Basing on SKYLAKE-U MRD BASE BOARD

Miix510 for Lenovo

Project: Miix510	
		Engineer: Jacky	
Size	Title: COVER PAGE	Rev	
Custom		V01	
Date: Wednesday, May 24, 2017	Sheet 1	of 69

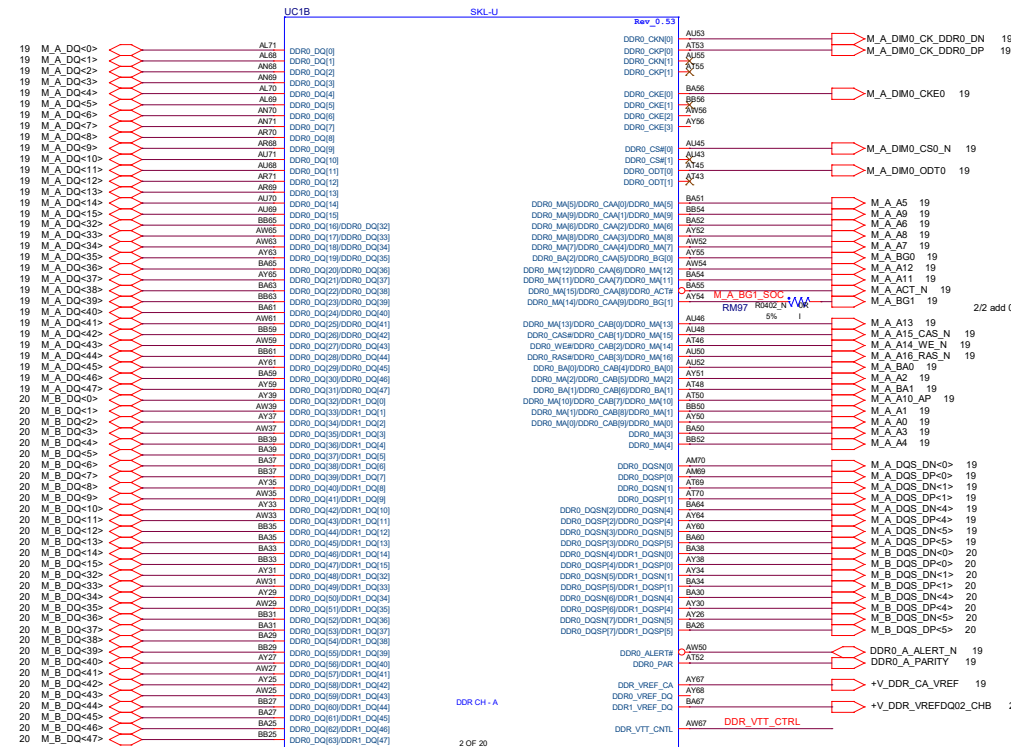
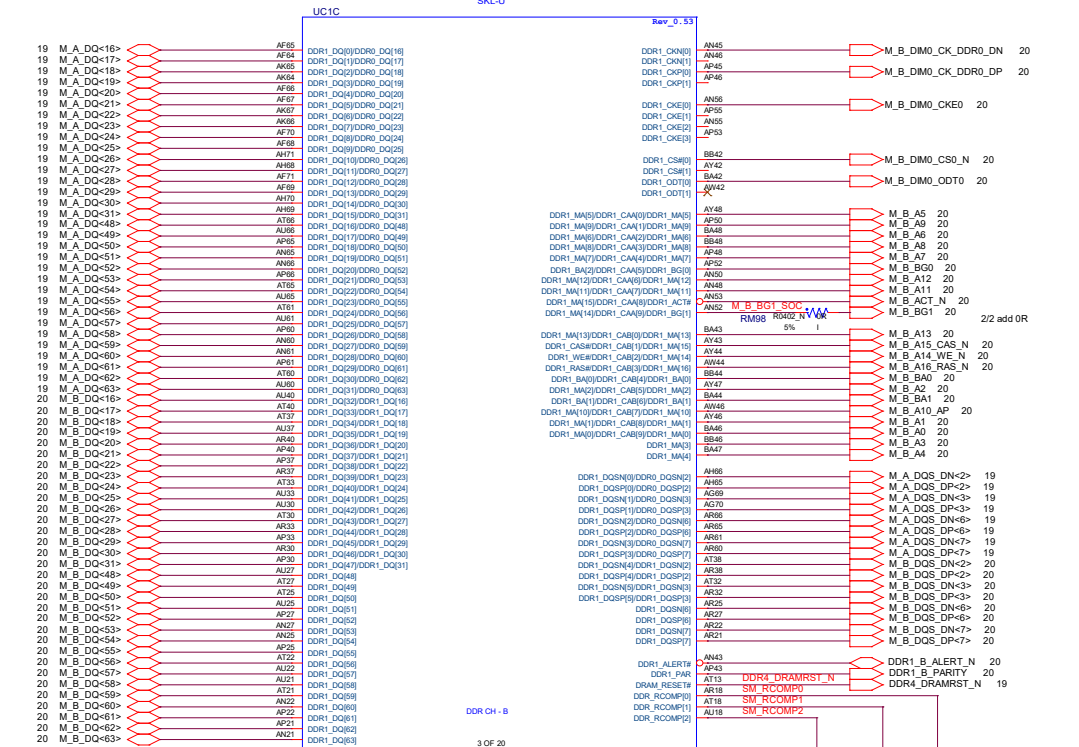
1. To support DDP, need to change two pins on DRAM. You have reserved them. Pls install the BOM.

X16 SDP	X16 DDP TwinDie
DRAM M9 pin	VSS	Connect to CPU BG1
DRAM E9 pin	VSS	UZQ

SDP	DDP
Memory size	4Gb or 8Gb	16Gb
DRAM M9 pin	RM95, RM96, RM97, RM98 need install	RM95, RM96, RM97, RM98 need install
DRAM E9 pin	RM79, RM81, RM83, RM85, RM87, RM89, RM91, RM93 need install 0 ohm	RM79, RM81, RM83, RM85, RM87, RM89, RM91, RM93 need install 240 ohm
DDR_RCOMP0	RM3 200R need install	RM3 121R need install

2/2 Add (4Gb 8Gb) & (16Gb) BOM option table

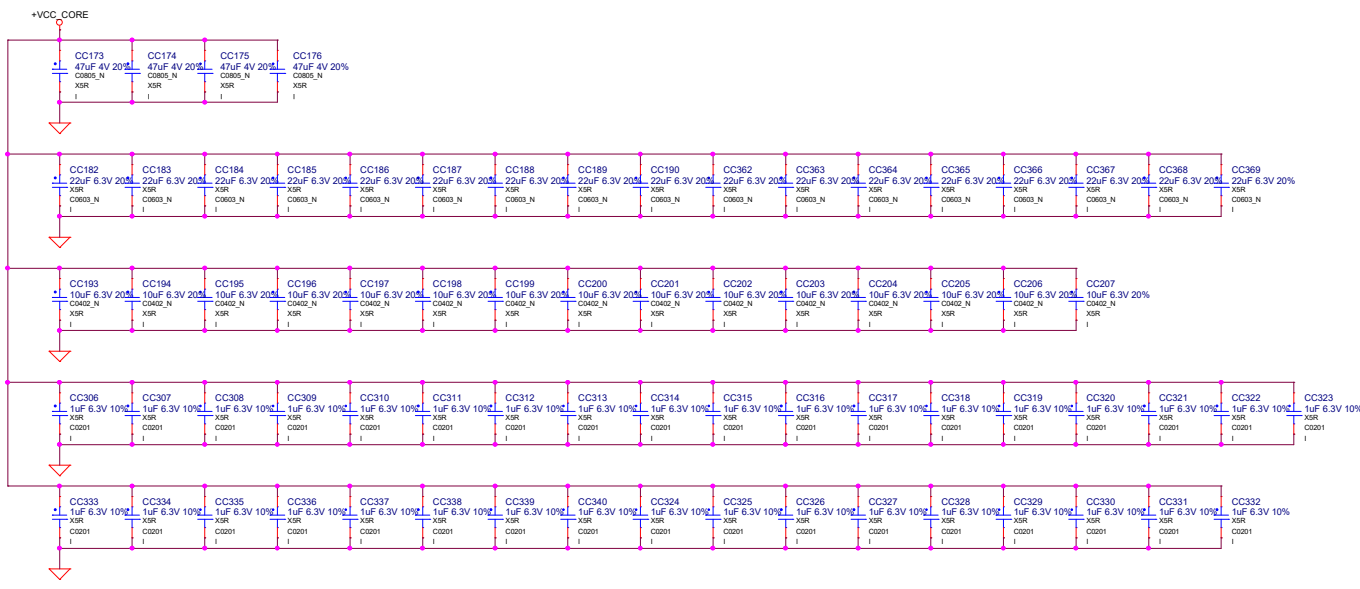
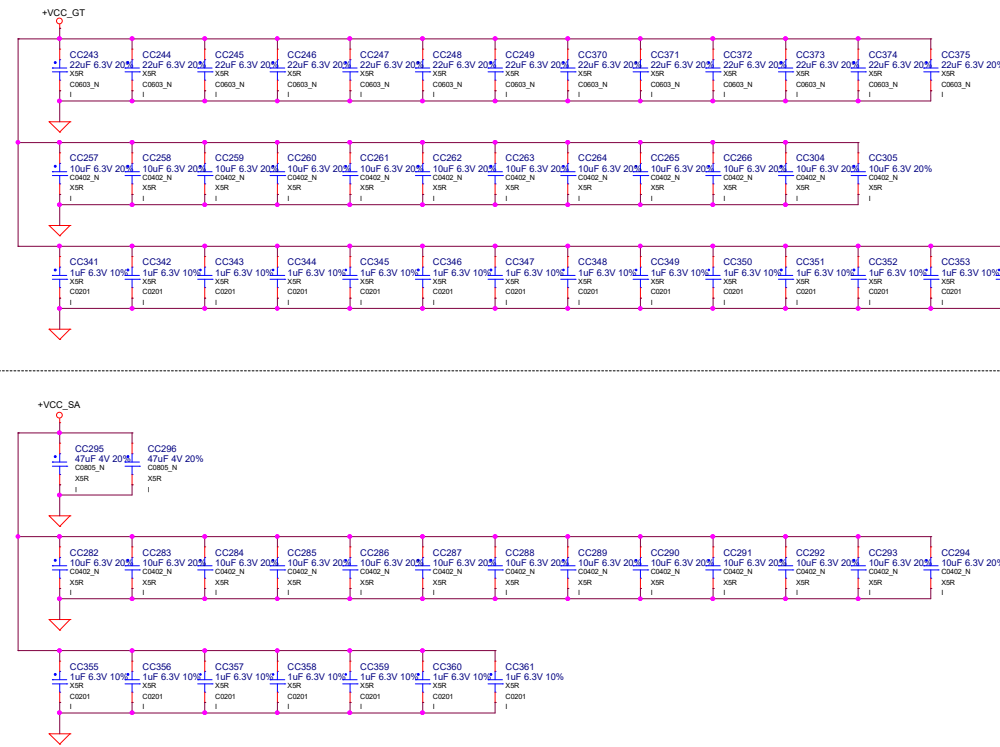
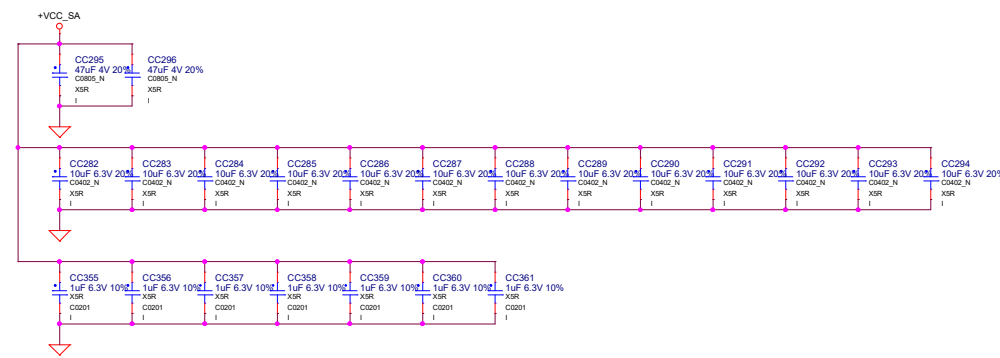
12/30 check PD6
& 220uF pull power side

change 47uF x4
cgange 22uF x17

12/30 check PD6
& 220uF pull power side

change 47uF x0
cgange 22uF x13

12/30 check PD6

Project: Miix510	
Size: Custom		Engineer: Jacky	
Title: PCIE SSD MODULE		Rev: V01	
Date: Wednesday, May 24, 2017		Sheet 26 of 69

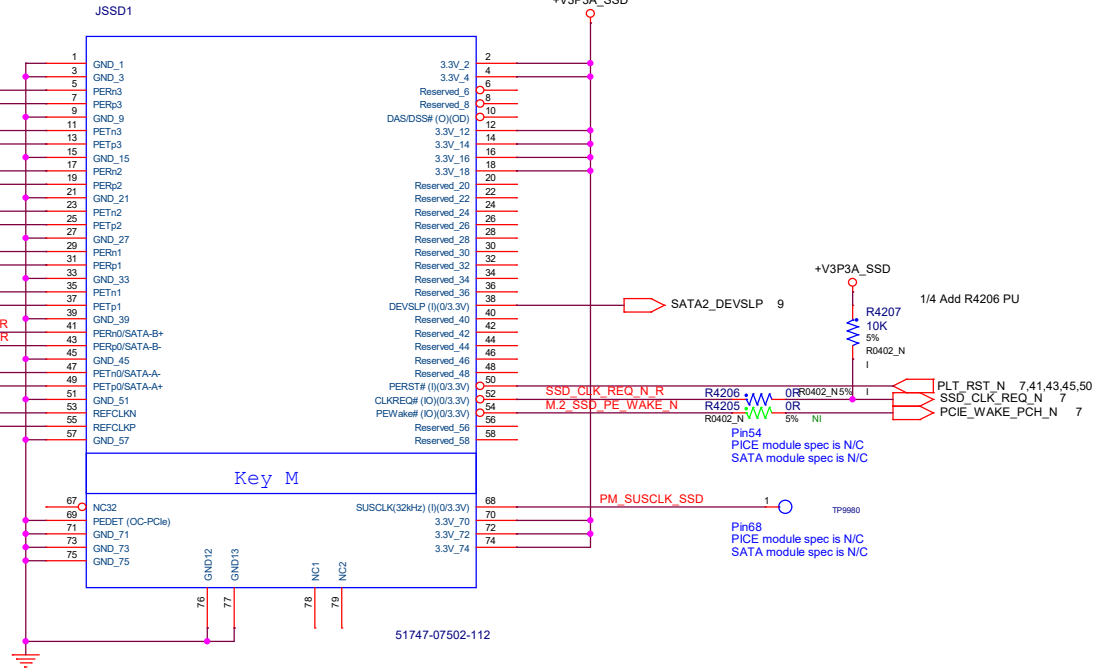
PCIE12 RX follow intel

Difference with intel
SSD interface SATA change to PCIE
If install SATA CARD, R4200, R4201 need install 0.01uF
C0606, C0607 need install 0.01uF

Co-lay PCIE12 RX, reserved R4202, R4203
please close to R4200, R4201

3/9 Del R4202, R4203, don't Co-lay PCIE12 RX

EDP DISPLAY 1920X1200 (12.2INCH)

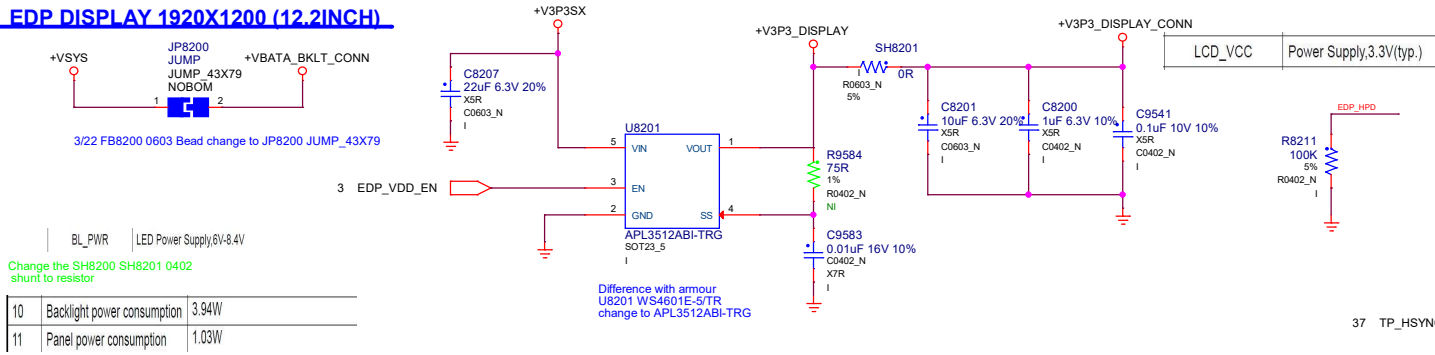
4/21 Del R9771,R9772,R9773,R9774,R9775,R9776 0ohm;
L9505,L9506,L9507 common choke,RF request

Camera Mclk

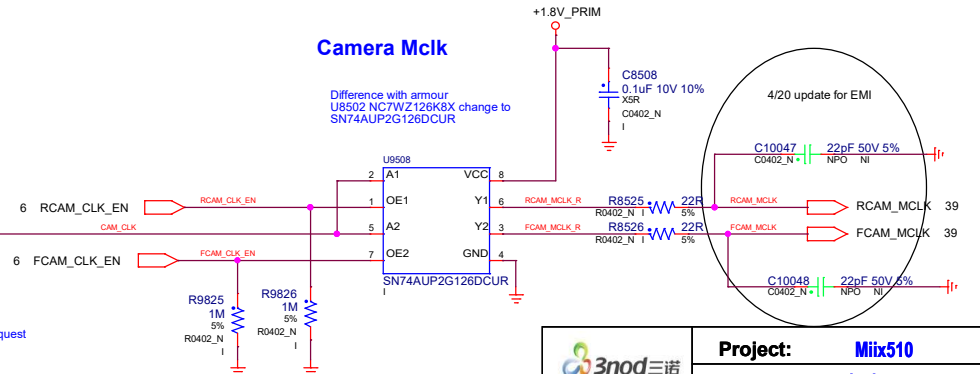
Difference with armour
 U8502 NC7WZ126K8X change to
 SN74AUP2G126DCUR

Shielding

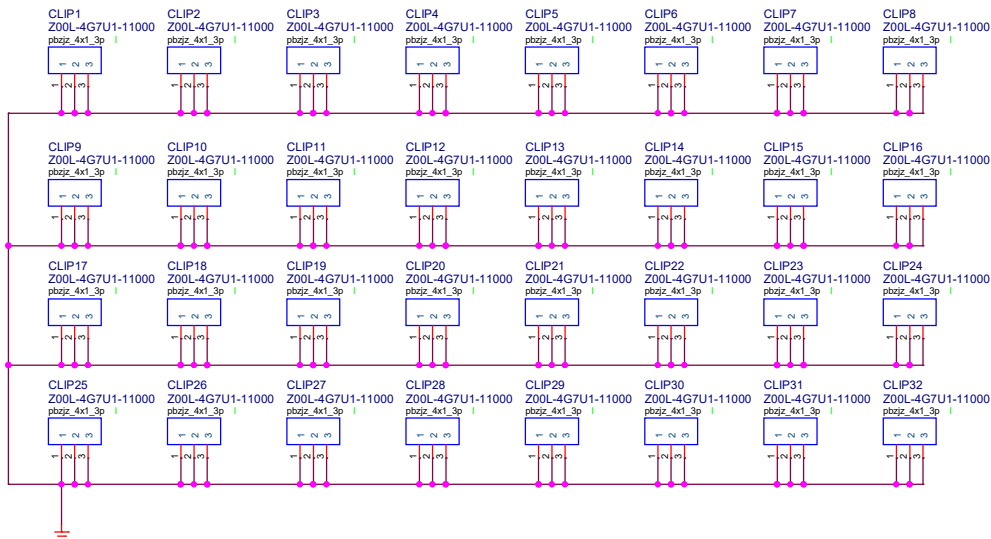
1/13 copy 11.6" NB Shielding

3/9 Del Z00L-4G7U1-11000(CLIP1~CLIP24),
add Z00L-4G7U1-11000(CLIP1~CLIP32)

5/5 footprint pbzjz_4x1_3p change to SHEILDING_CASE_3P_OP8X4.SMT request

Holes

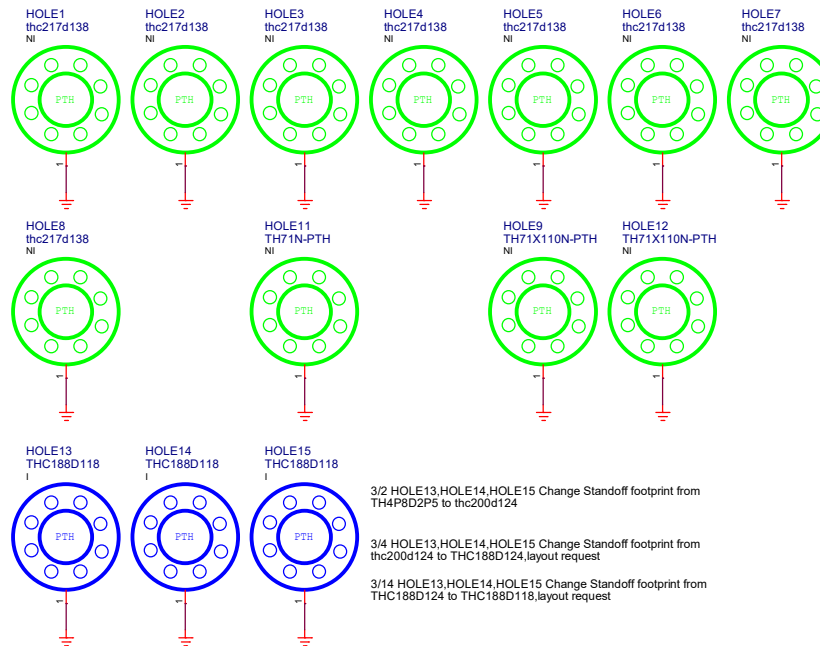
3/2 HOLE13,HOLE14,HOLE15 Change Standoff footprint from TH4P8D2P5 to thc200d124

3/4 HOLE13,HOLE14,HOLE15 Change Standoff footprint from thc200d124 to THC188D124,layout request

3/14 HOLE13,HOLE14,HOLE15 Change Standoff footprint from THC188D124 to THC188D118,layout request
